Errata: CS4341 Rev. C**CS4341 24-Bit, 96 kHz Stereo DAC with Volume Control**

All references to the CS4341 mentioned below shall be taken to refer to revision C of the CS4341 product. The hardware revision code can be found in the 10 character field printed below the part number on each chip. The letter which appears as the fifth character from the right is the revision code (e.g. ZNACSC9926 is a Revision C part).

Figure 1. I²C SCL Buffer Example

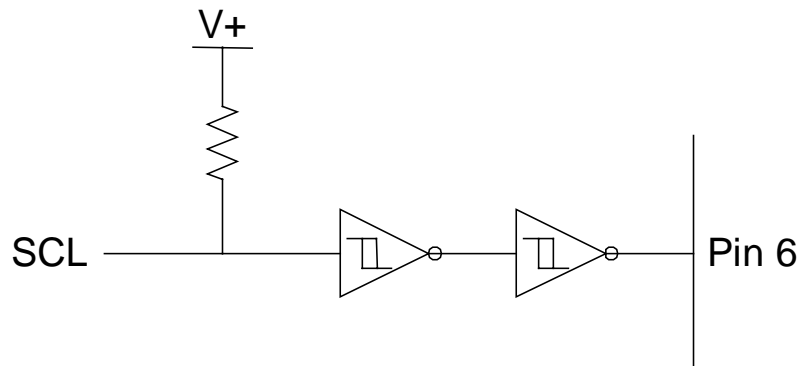
Pin 6 (SCL/CCLK) of the CS4341 does not have sufficient hysteresis to meet the data sheet rise time specifications. The I²C rise time t_r and the SPI rise time t_{r2} must be less than 30 ns for proper operation. This prevents the use of standard I²C configurations with a resistor pull-up. This problem can be worked around by placing a Schmitt Trigger buffer, for example a 74HC14, on the SCL line just prior to the CS4341. This will not affect the operation of the I²C bus as pin 6 is an input only.
